TITLE: Waiver from Double Liner Requirements Pursuant to Section 3015 (b) (1) and 40 CFR Section 265.301(c) for CECOS International Inc., Williamsburg, O

"Waiver from Double Liner Requirements Pursuant to Section 3015(b)(1) and 40 CFR Section 265.301(c)" for CECOS International, Inc., Williamsburg, Ohio, Landfill Cell No. 9.

SUBJECT: CECOS International, Inc., Williamsburg, Ohio, Landfill
Cell No. 9--Waiver from Double Liner Requirements

WAIVER EVALUATION FOR
CECOS INTERNATIONAL ABER ROAD FACILITY
SECURE CHEMICAL MANAGEMENT FACILITY NO. 9
CLERMONT COUNTY, OHIO
OCTOBER 1985

Figure 1. Schematic of Interim Statutory Design

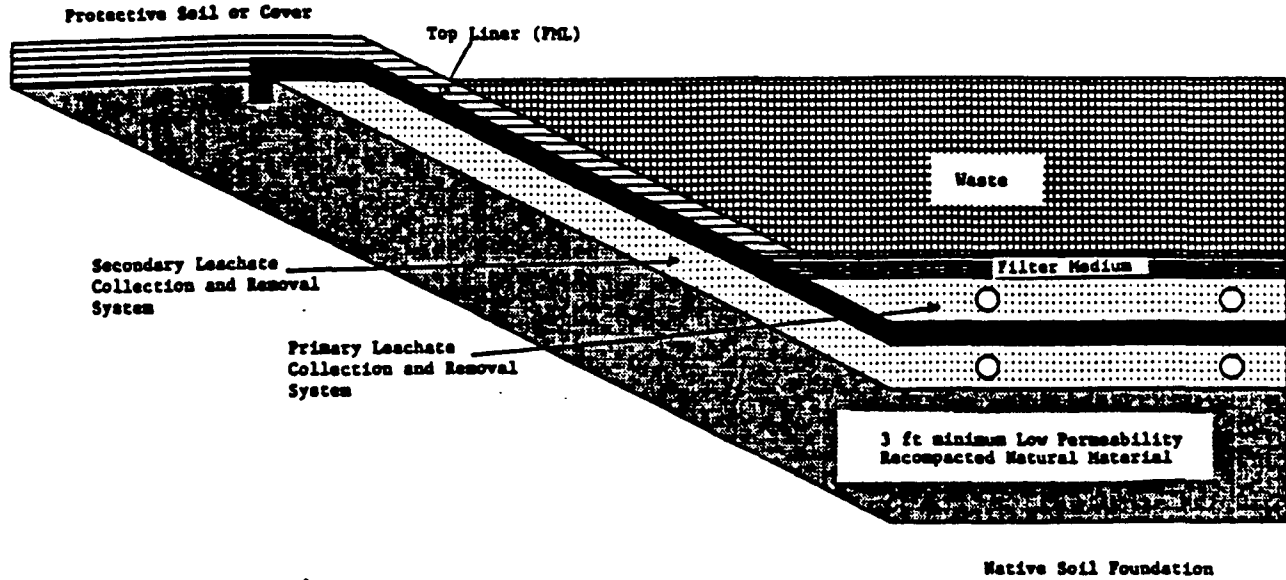
The interim statutory design includes a primary leachate collection and removal system. The top liner in this design consists of a liner designed, operated, and constructed to prevent the migration of any constituent into such liner during the active life and post-closure care period (i.e., a flexible membrane liner (FML)). A secondary leachate collection system is between the two liners on the bottom and sidewalls to detect, collect, and remove liquids entering the collection system. The lower liner consists of a liner designed, operated, and constructed to prevent the migration of any constituent through such liner during the active life and post-closure care period. HSWA specifies that the bottom (lower) liner be deemed to satisfy this requirement if it is constructed of at least a 3-foot thick layer of recompacted clay or other natural material with a permeability of no more than 1×10^{-7} cm/sec. Figure 1 is a schematic of the interim statutory design.

Figure 2. Schematic of CECOS Cell No. 9 Design.

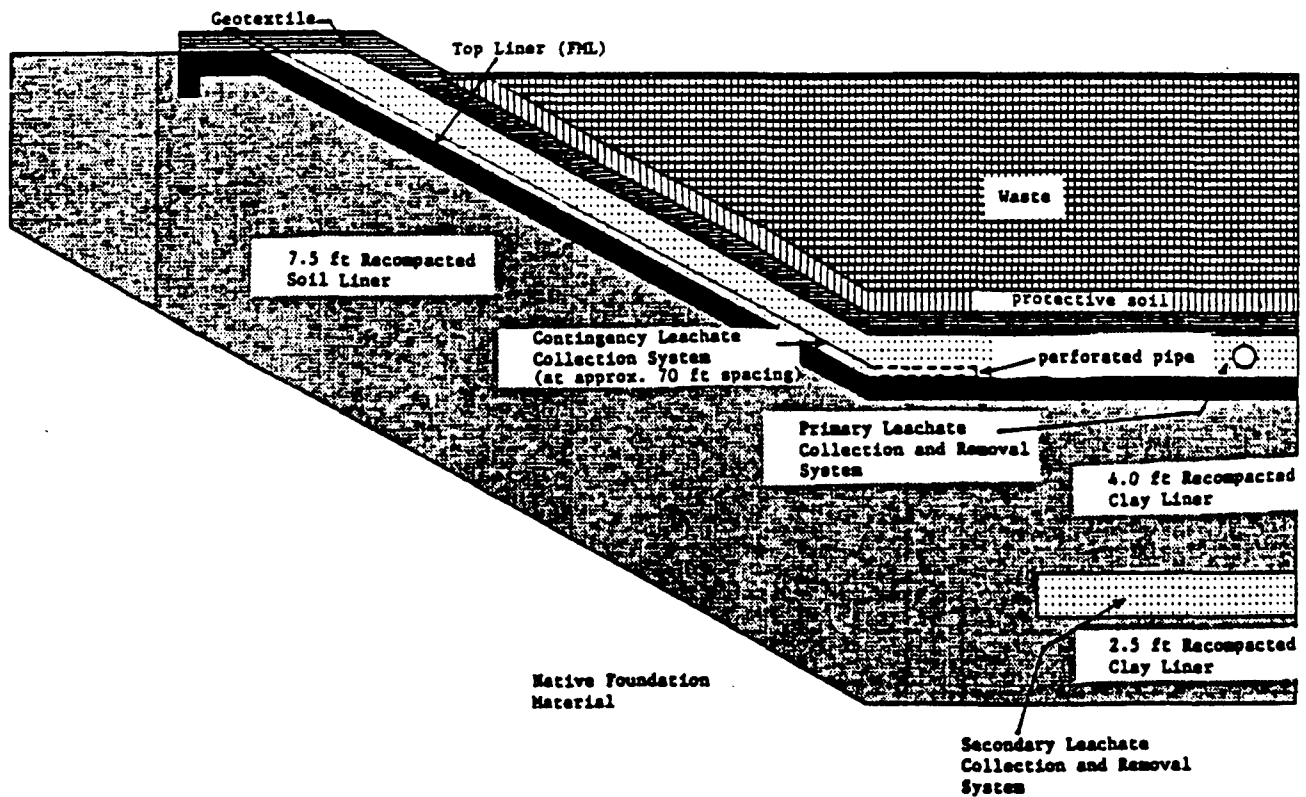
The design of CECOS' Cell Number 9 deviates from the requirements of Section 3004(o)(1) of the SWDA and 40 CFR §265.301(a) by the failure to have a secondary leachate collection system that covers all areas of the landfill between the top and bottom liners. This deficiency is compensated for, as documented by the CECOS AS-BUILT drawing, sheet number 7, dated January 31, 1985, by the inclusion of a primary sidewall contingency leachate collection system and a thicker compacted lower soil liner than is provided for in the interim statutory design contained in Section 3004(o)(5)(B) of the SWDA and 40 CFR §265.301(a).

A schematic representation of the CECOS Cell No. 9 is shown in Figure 2. The sidewall liner system consists of, from top to bottom, a protective soil layer, a geotextile, 1 foot of sand (leachate collection layer), a geotextile, the FML, and a 7.5-foot compacted soil liner (bottom or lower liner). The sidewall slope is 2:1 (horizontal to vertical). Eight 6-inch pipes, spaced approximately equally around the cell, are located in the sand layer on the sidewalls and extend 5 ft. into the primary leachate collection and removal layer at the bottom of the cell. These pipes are perforated in the bottom layer and function as a contingency leachate collection and removal system. This contingency leachate collection system is a very important element of Cell No. 9 because it is designed to provide additional and backup capability to remove liquids from the sidewall area.

The cell bottom liner system, from top to bottom, consists of a protective soil layer, a geotextile, 1 foot of sand (primary leachate collection and removal system), the FML, 4 feet of compacted clay, 1 foot of sand (secondary leachate collection and removal system), and 2.5 feet of compacted clay (secondary liner). The secondary leachate collection system is located below the 4 feet of compacted clay except near the sidewall/bottom interface and under a center berm. An additional leachate monitoring system is located below the 2.5 feet of clay layer as a requirement under Toxic Substance Control Act regulations (not shown in Figure 2). For specific details of the design see AS-BUILT Drawing.¹

To continue to qualify for this waiver, the alternative design and operation of the primary leachate collection system (including the contingency sidewall collection and removal system) must include:

- 1) A primary leachate collection sump conveyance system capable of automatic and continuous functioning.
- 2) A primary leachate collection system on the cell's sidewall consisting of the following components (see CECOS' AS-BUILT drawing, January 31, 1985, sheet No. 7) above the top liner:
 - ° 6-ounce protective geotextile.
 - ° 1-foot sidewall washed sand blanket with a hydraulic conductivity of 1×10^{-3} cm/sec or more.

- Contingency leachate collection piping consisting of 6-inch ABS schedule 80 pipe up the sidewall at 8 locations (at approximately 70-foot spacing). The pipes extend 5 feet into the primary leachate collection and removal system at the bottom of the cell. This 5-foot section is perforated and functions as a contingency leachate collection system (see CECOS' AS-BUILT drawing, January 31, 1985, sheet No. 9).

Figure 3. Maximum Release Rates

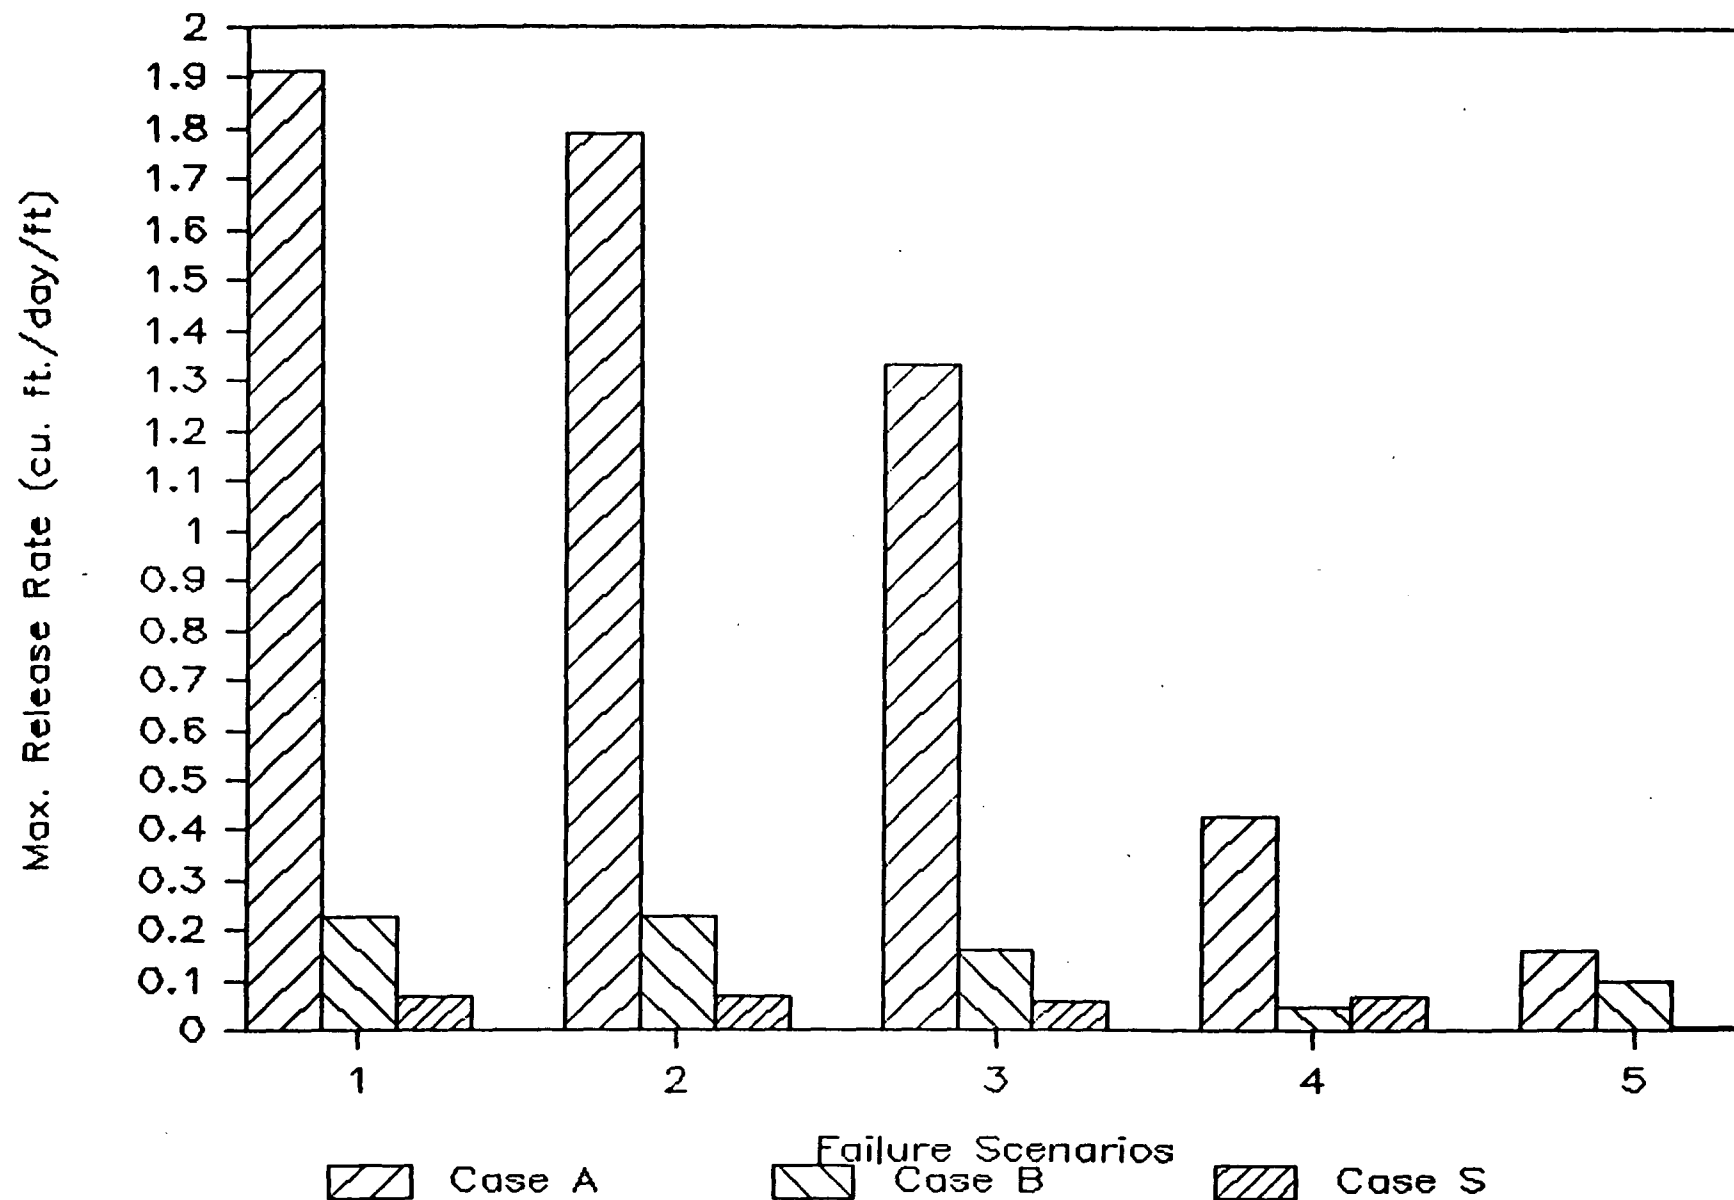
feet per day from a one-foot slice of the landfill sidewall from top to bottom) because the CFEST model analysis is based on a cross-section of each design. Flows at or near the sidewall are either released through the sidewall (i.e., maximum release rate through sidewall) or collected by the secondary or contingency leachate collection systems. These rates are maximum values because of the high constant head conditions assumed in this analysis. Because CECOS' Cell No. 9 only has a secondary leachate collection system on the bottom of the cell (i.e., no sidewall secondary leachate collection system), very little flow from the sidewall reaches the secondary leachate collection system.

Figure 4. Drainage Time (days)

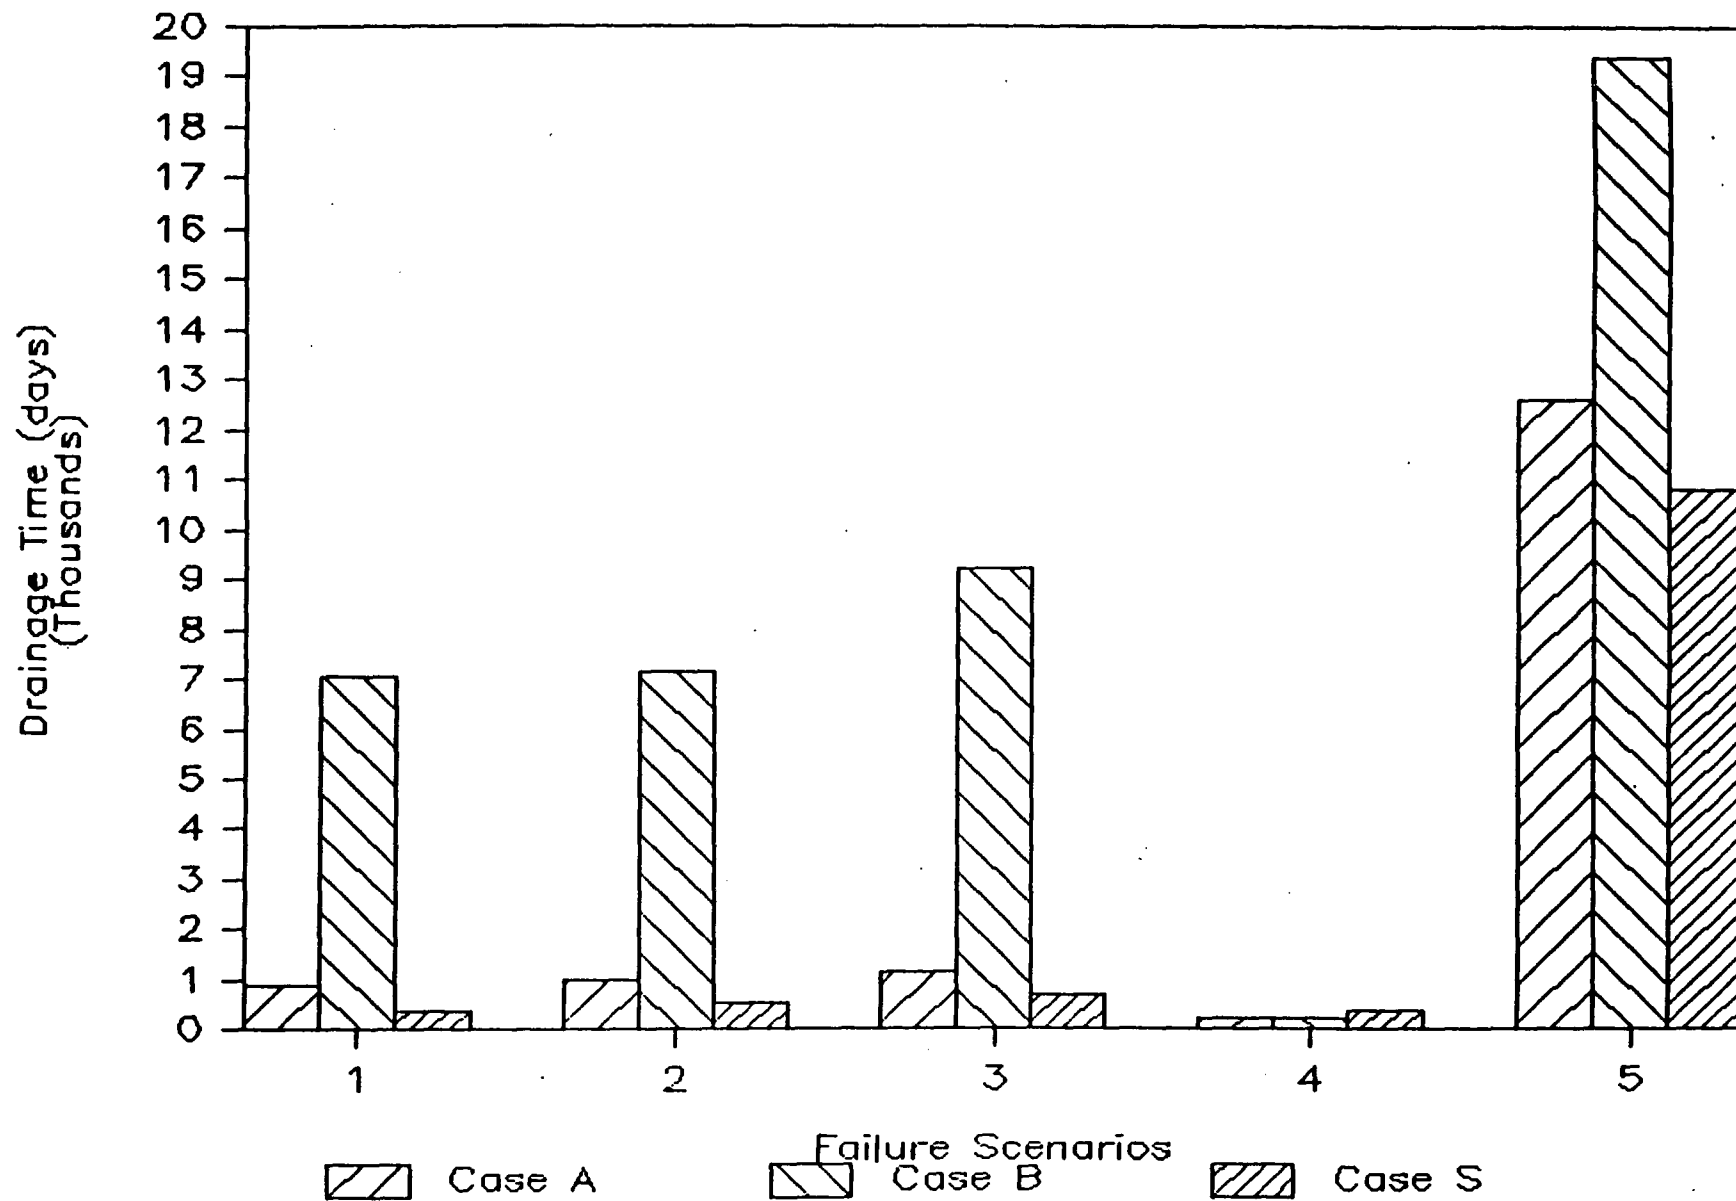
The drainage times presented in Table 4 and Figure 4 are calculated by dividing the total amount of liquids within each design by the flow rate through the secondary and/or contingency leachate collection systems. The drainage time factor relates directly to the length of time a release could occur given that the secondary or contingency leachate collection systems were being operated to remove all liquids from the landfill. Remember, however, that this analysis has a constant head, while under normal field conditions, the head would be declining eventually to zero if all liquid input into the cell were eliminated. Table 4 also contains the volume exiting the sidewall during the drainage time. These values are determined by multiplying the maximum release rates by the drainage time. These volumes are another measure of the effectiveness of each design. The physical significance of these volumes is that while liquids are being removed by the secondary or contingency leachate collection systems, releases through the sidewall will occur; thus, more effective collection systems will reduce the volume of liquids released to the environment.

Figure 5. Breakthrough Times (days)

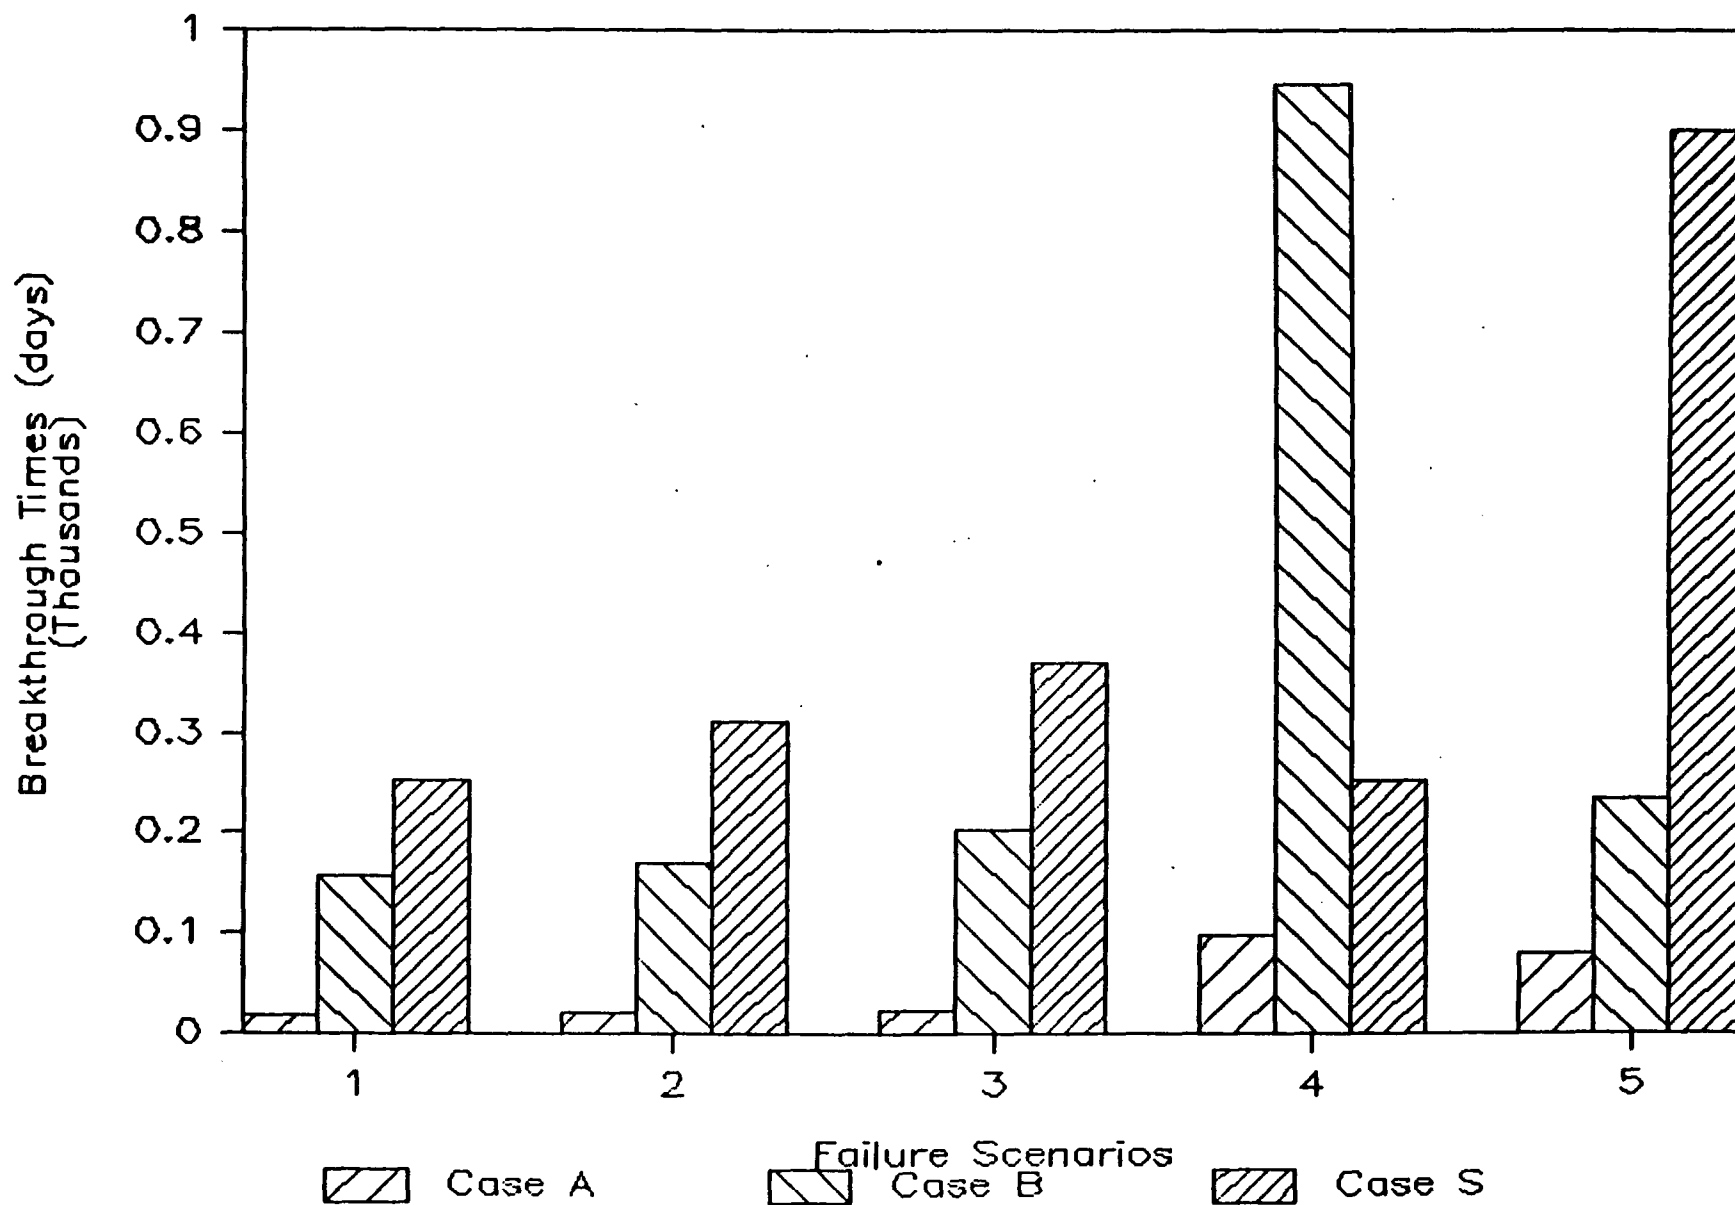
Breakthrough times are presented in Table 4 and Figure 5. Breakthrough times represent another measure of performance of each design but because of the drastic head conditions and conservative breakthrough equation, these values have little resemblance to breakthrough times that would occur under less severe conditions (i.e., normal field conditions). The relative relationship between breakthrough times for various designs and operating conditions should, however, be similar with the smaller heads that are more likely to occur in an actual landfill.
